#### P&A Procedure

#### BP America - FLETCHER 2

Well: Fletcher 2

### **CONDITIONS OF APPROVAL**

#### Proposed P&A

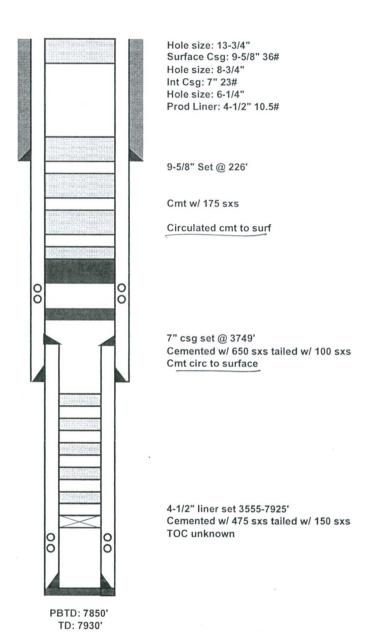
- 1. Plugging operations authorized are subject to the attached "General Requirements for Permanent Abandonment of Wells on Federal and Indian Lease."
- 2. Farmington Office is to be notified at least 24 hours before the plugging operations commence (505) 564-7750.
- 3. The following modifications to your plugging program are to be made:
  - a) Set Plug 1 (3060 2874) ft. to cover the Fruitland top. BLM picks top of Fruitland at 2924 ft.
  - b) Set Plug 2 (2169 1988) ft. to cover the Kirtland and Ojo Alamo tops. BLM picks top of Kirtland at 2119 ft. BLM picks top of Ojo Alamo at 2038 ft.

You are also required to place cement excesses per 4.2 and 4.4 of the attached General Requirements.
